Ash Landfill Biowall Recharge Seneca Army Depot Activity

FINAL WORK PLAN
Ash Landfill Biowall Recharge
SENECA ARMY DEPOT ACTIVITY

Army's Response to Comments from the New York State Department of Environmental Conservation

Subject: Draft Work Plan for the Ash Landfill Biowall Recharge at Seneca Army Depot
Seneca Army Depot Activity
Romulus, New York

Exhibit 4.1
 Drilling and Injection Costs (not including injection materials)
 Versus Well Spacing

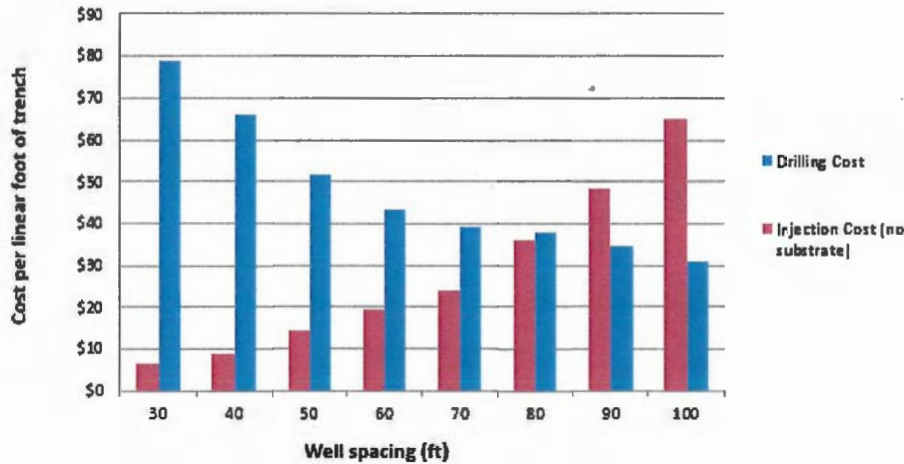
Comment 2: Section 4.1.2: I question whether the 80 to 90-foot spacing between the recirculation wells may be too much space between the wells to be effective.

Response 2: The principles and practices manual (which was prepared by Parsons) is focused on applying enhanced bioremediation in natural media (injection into saturated soil) where substrate distribution away from an injection well is radial because the subsurface media is generally homogeneous. In a natural media setting, a 90-foot injection well spacing would require huge injection volumes and would not generally achieve the desired results. In the case of the Seneca Ash Landfill, we are refreshing a biowall which is generally a linear structure of very high permeability material installed in soil of comparatively low permeability. Thus, during injection (and extraction) substrate distribution will be forced along the trench radically increasing distribution in the "along trench" direction and in the direction of the extraction well. Reference page 5-11, section 5.4.2, Recirculation of the Principles and Practices of Enhanced Anaerobic Bioremediation of Chlorinated Solvents (2004) where it states "Highly permeable and uniform lithologies are required to use well spacings on the order of 50 to 100 feet."
